ADDENDUM NO. 1

**ARCADIA HIGH SCHOOL
LOCKER ROOM ALTERATION
ARCADIA UNIFIED SCHOOL DISTRICT**

tBP/ARCHITECTURE
4611 Teller Avenue
Newport Beach, CA 92660
949-673-0300

This Addendum forms a part of the Contract Documents and modifies the original Bidding Drawings dated August 15, 2024, and Specifications dated July 2024. Acknowledge receipt of this Addendum in space provided on the Bid Form. Failure to acknowledge may subject Bidder to disqualification.

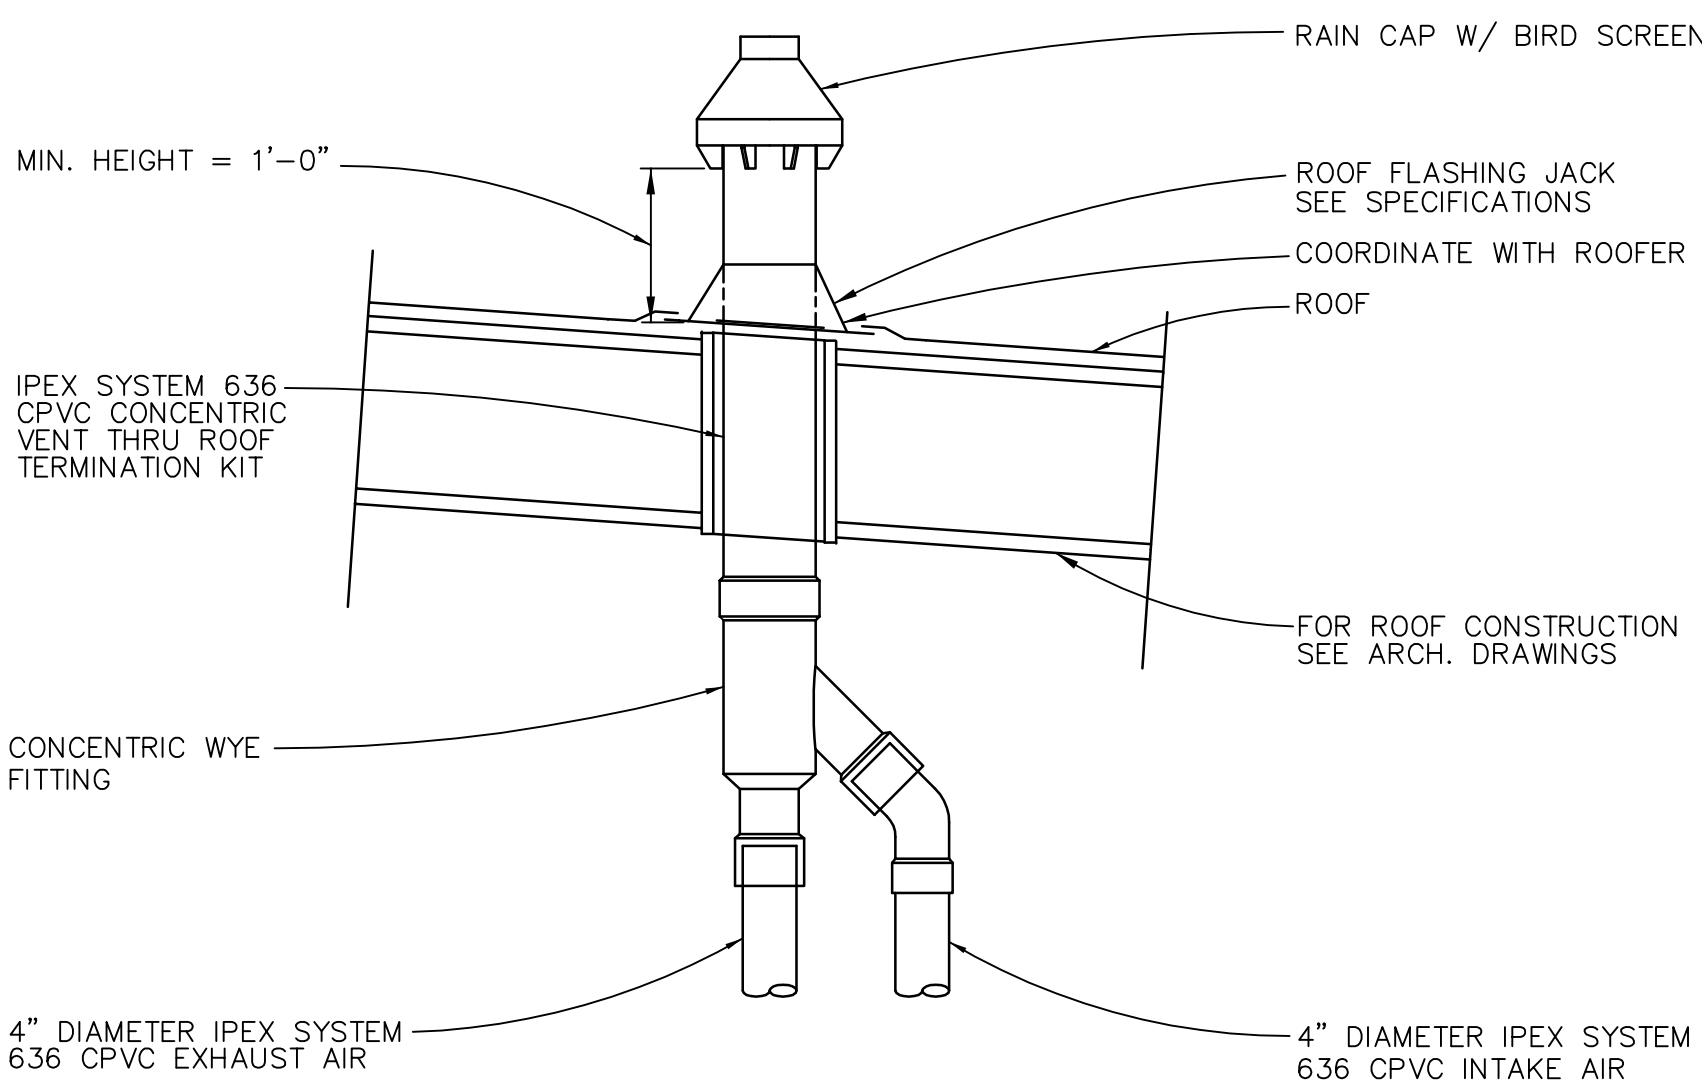
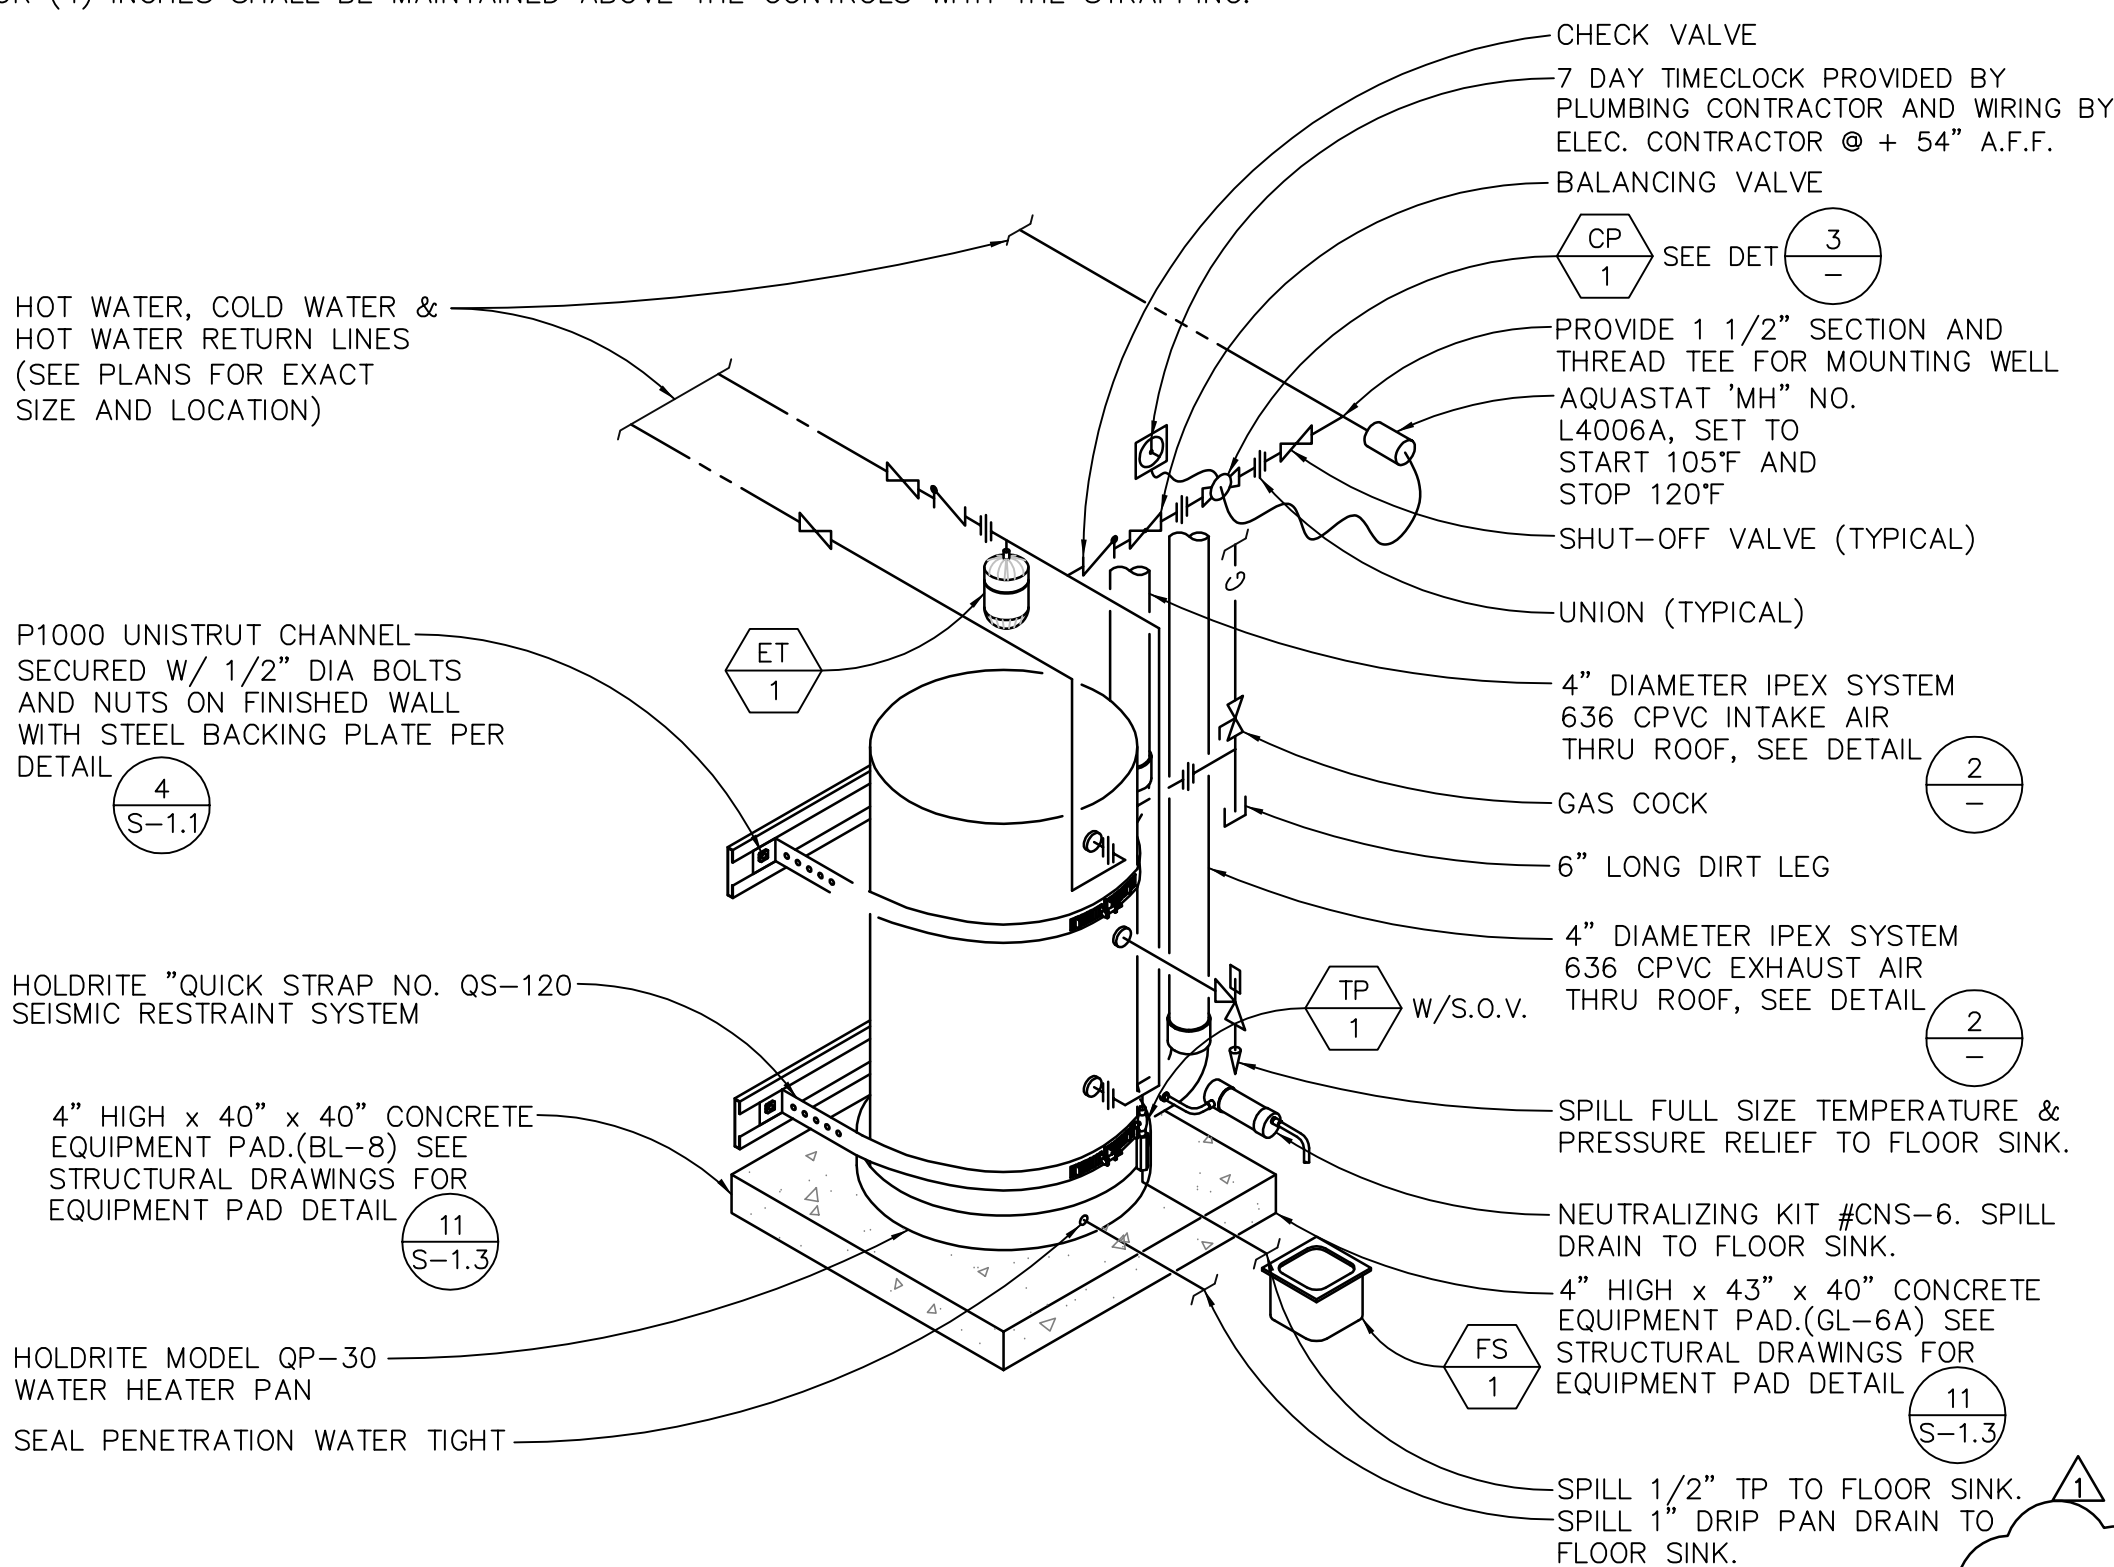
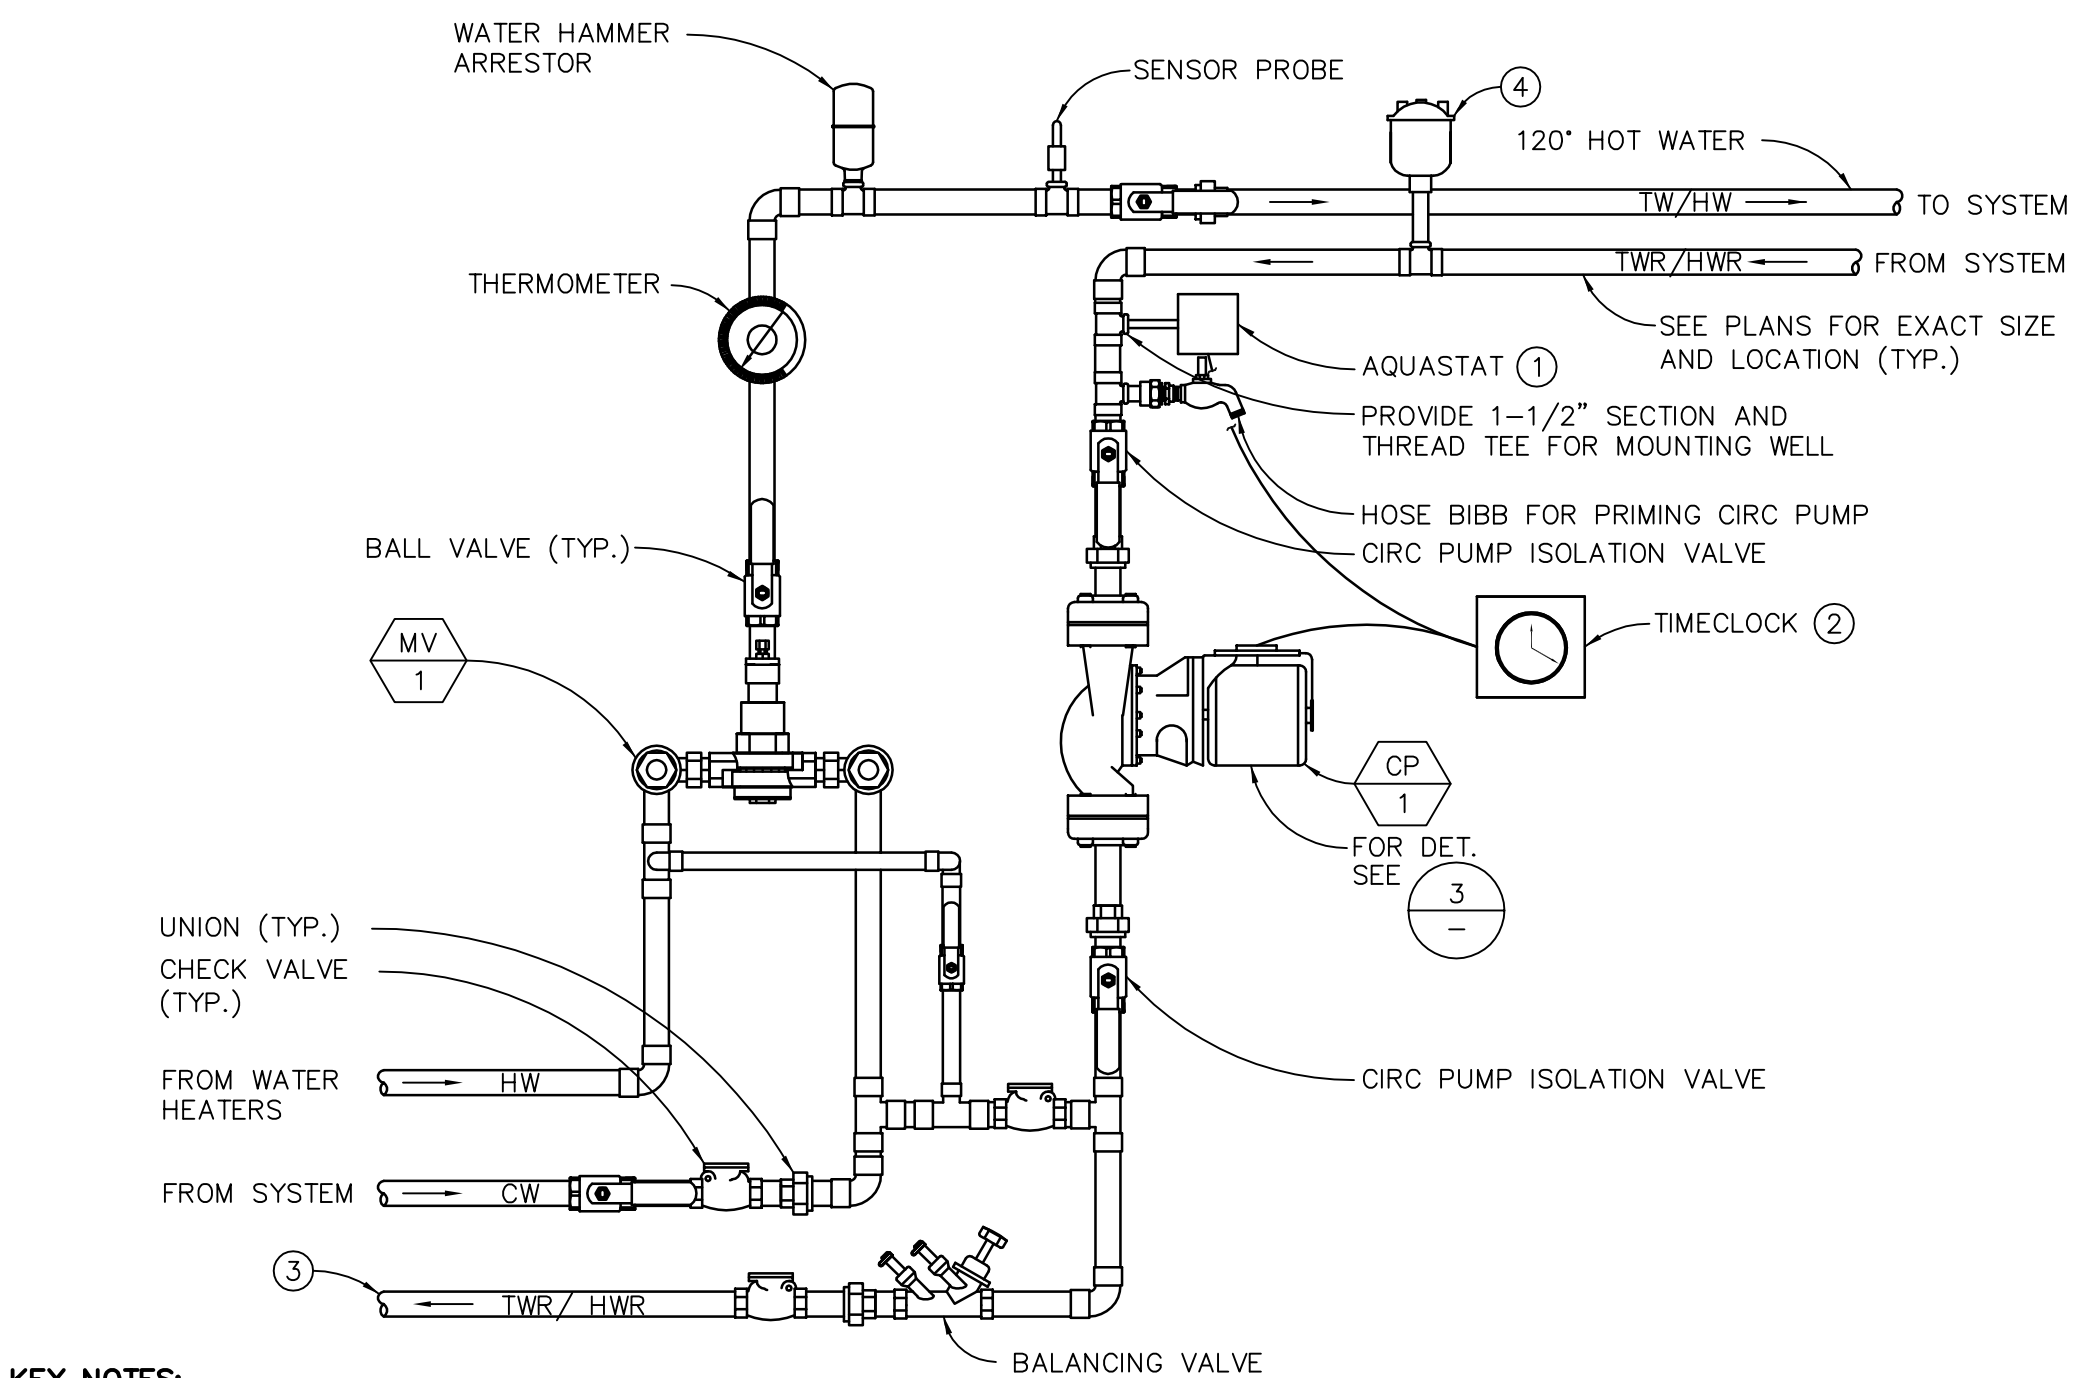
- a. Revise water heater connections per Detail 1/P4-1.
- b. Provide vent at roof per Detail 2/P4-1.
- c. Provide circulation pump wiring per Detail 3/P4-1.
- d. Provide mixing valve and circulation pump connection per Detail 4/P4-1.
